10/633,450

Office Action Summary

HARTY, ROBERT D.

DETAILED ACTION

FIG. 1

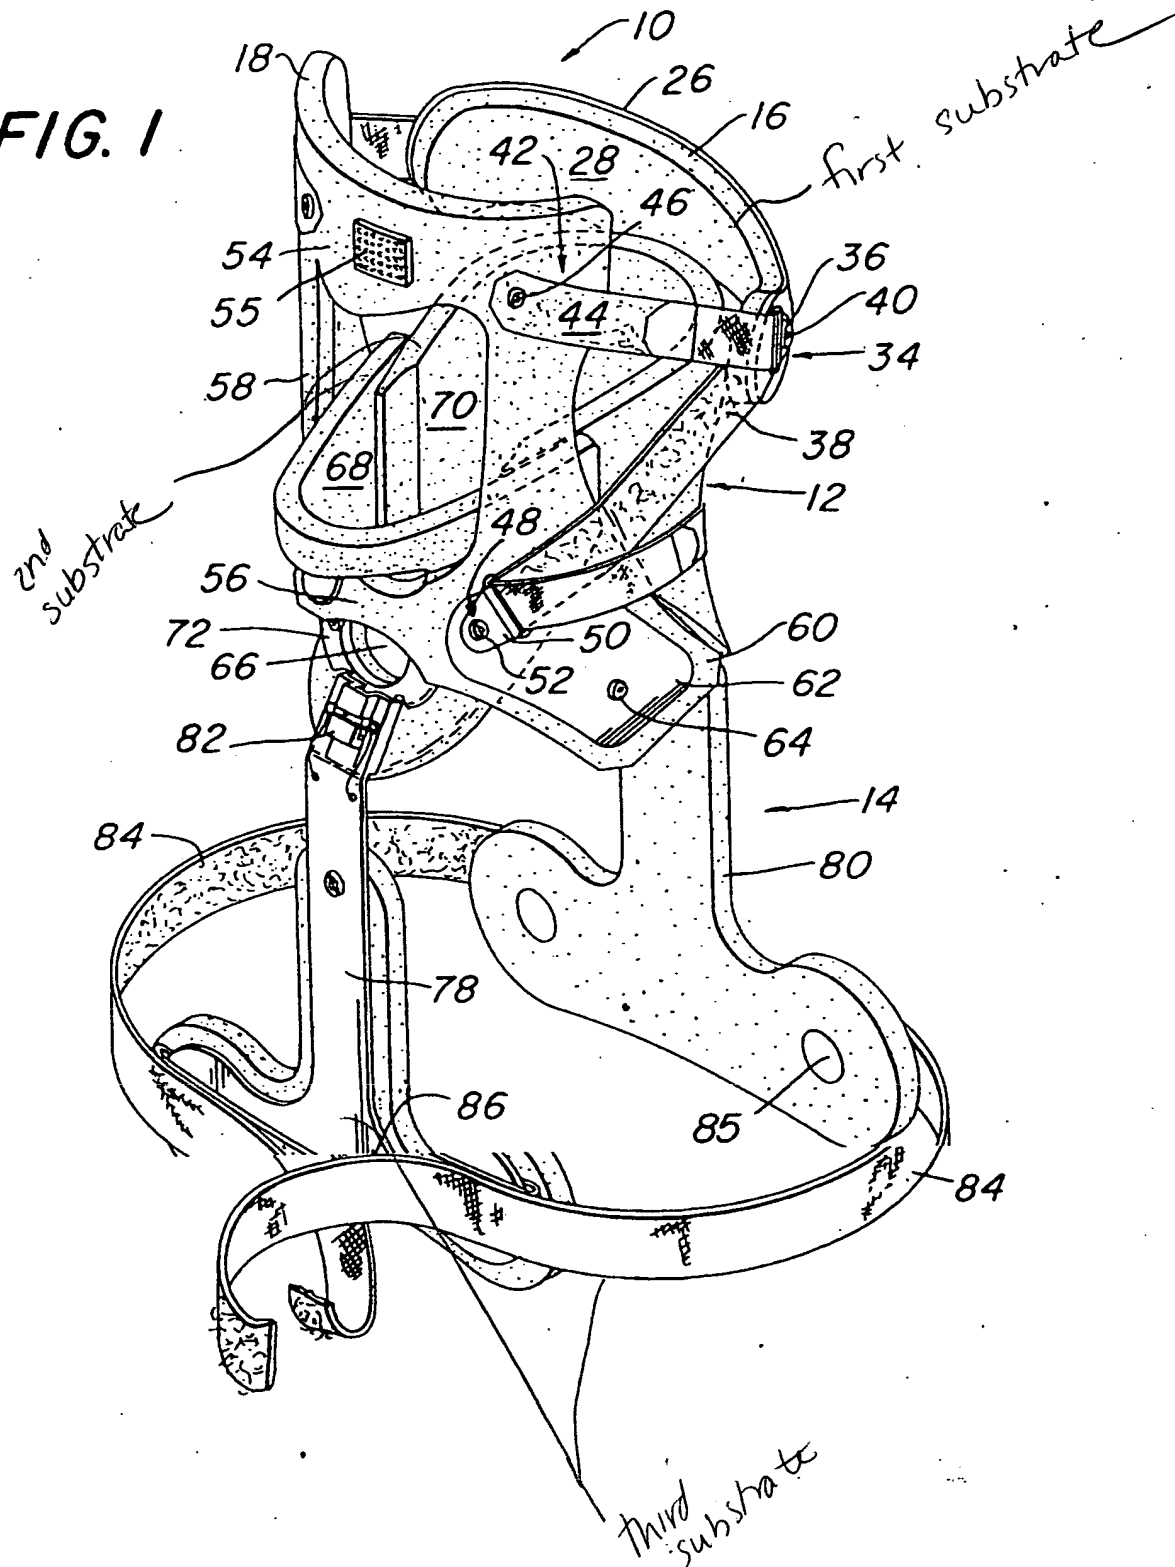
As regards claim 1, Calabrese et al. disclose a medical collar that anticipates applicant's invention. The collar immobilizes the head, neck and upper torso of a patient, and as can be seen from marked-up Fig. 1, comprises a first substrate for supporting the back of the patient's head; a second substrate in communication with the first substrate, whereby the second substrate is adapted to encircle the patient's neck;

and a third substrate in communication with the second substrate, whereby the third substrate contacts the patient's chest.

FIG. 24

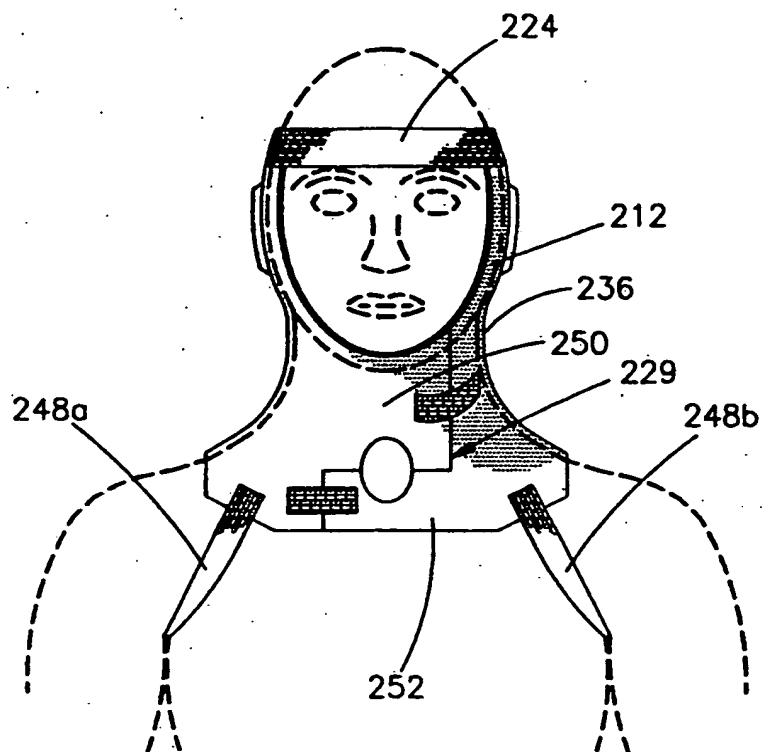
As regard claim 1, Schmidt discloses a support device that immobilizes the head, neck and upper torso of a patient, and as can be seen from marked-up Figs. 24 and 25, comprises a first substrate for supporting the back of the patient's head; a second substrate in communication with the first substrate, whereby the second substrate is adapted to encircle the patient's neck; and a third substrate in communication with the second substrate, whereby the third substrate contacts the patient's chest.
